Rezoning Transportation Analysis

Petition Number: #2022-107

General Location Identifier: 08119159

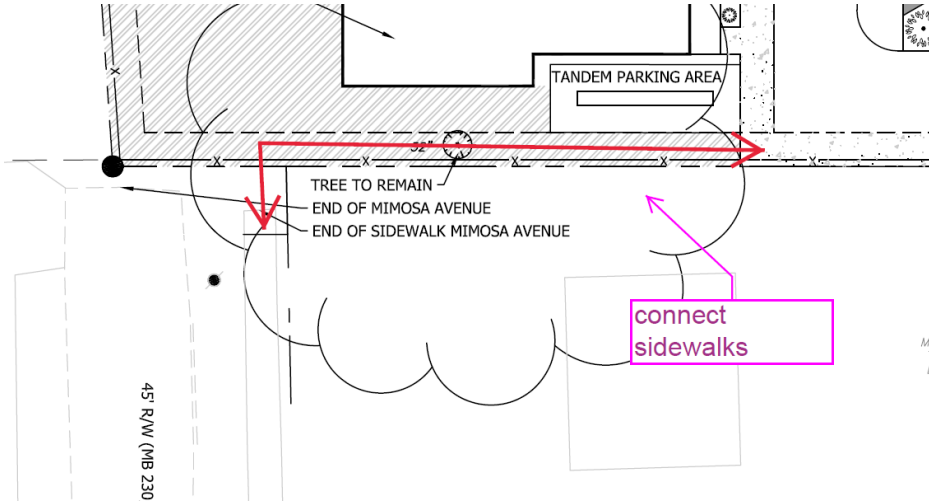
3. ~~**Outstanding Comment from 11-28-22**~~ Revise site plan and conditional note(s) to commit to dedicate 56 feet of right of way from the road centerline. The site plan shall label and dimension the right of way from the road centerline.

Clarified Outstanding Comment from 03-21-22 Site plan only shows hatched area, petitioner should label and dimension the right of way from the centerline for each road on the site plan.

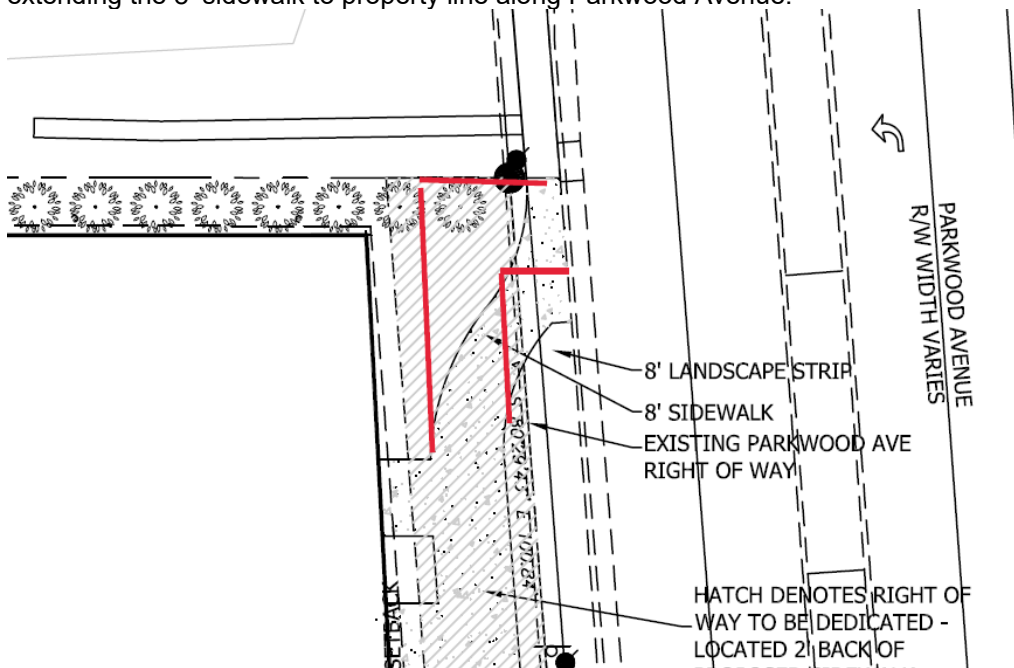
Clarifying comment from 12/22/2022: Commit to connect sidewalk near single family structure to existing sidewalk on Mimosa Avenue as shown above.

- 6. ~~Comment rescinded 03-23-23~~ Site plan and conditional note(s) revisions are needed to commit to extending the 8' sidewalk to property line along Parkwood Avenue.

Clarifying comment from 12/22/2022: Extend 8-foot sidewalk as shown above to property line along Parkwood Avenue.

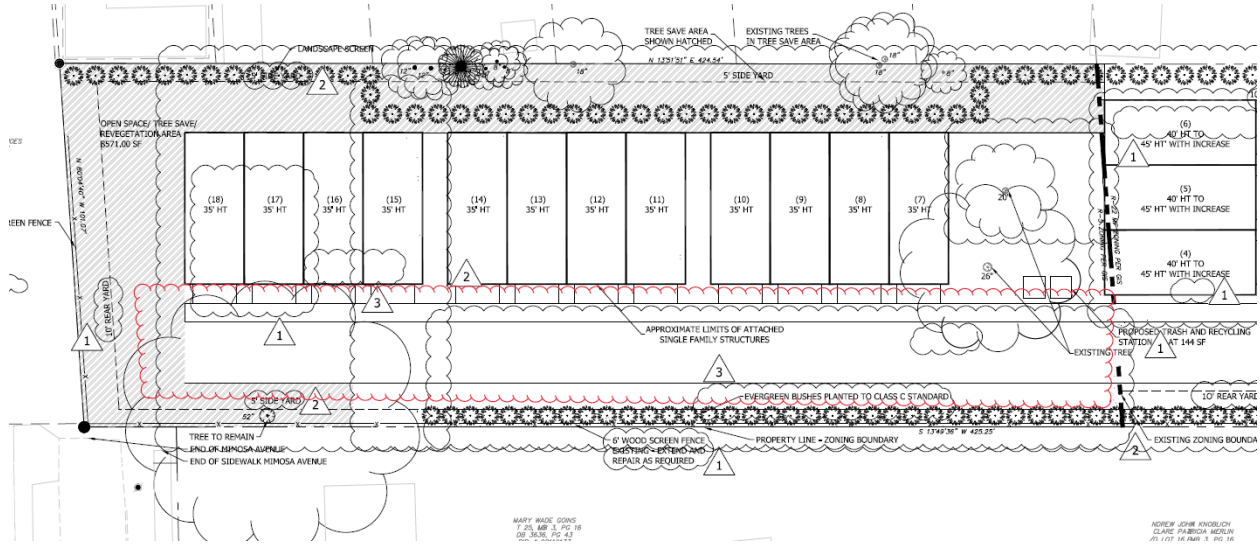
- 7. ~~New Comment 11-27-23~~ Revise site plan to accommodate Fire and solid waste vehicle turnaround requirements.
